Subject: Design change of terminal used in 250FH fuses

Product dimensions with current terminal

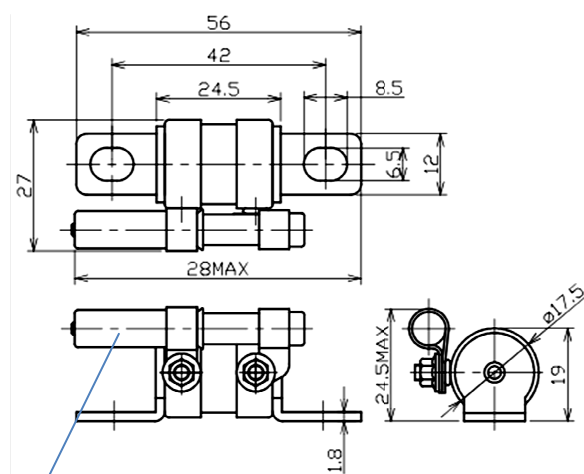
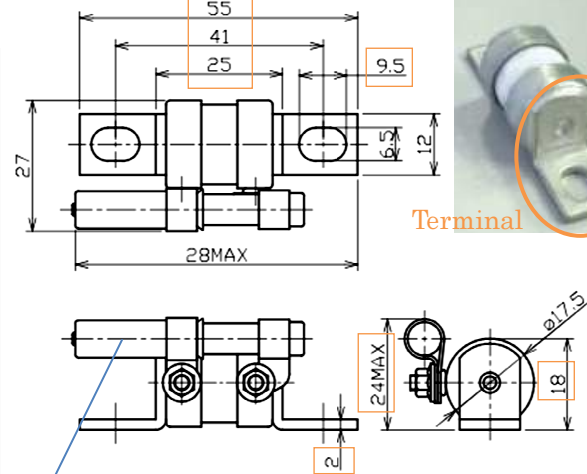
Change will be made only to the terminal shape and thickness.

The installation pitch will change from 42mm to 41mm; however installation compatibility will be maintained with a longer screw hole.

Product dimensions with new terminal
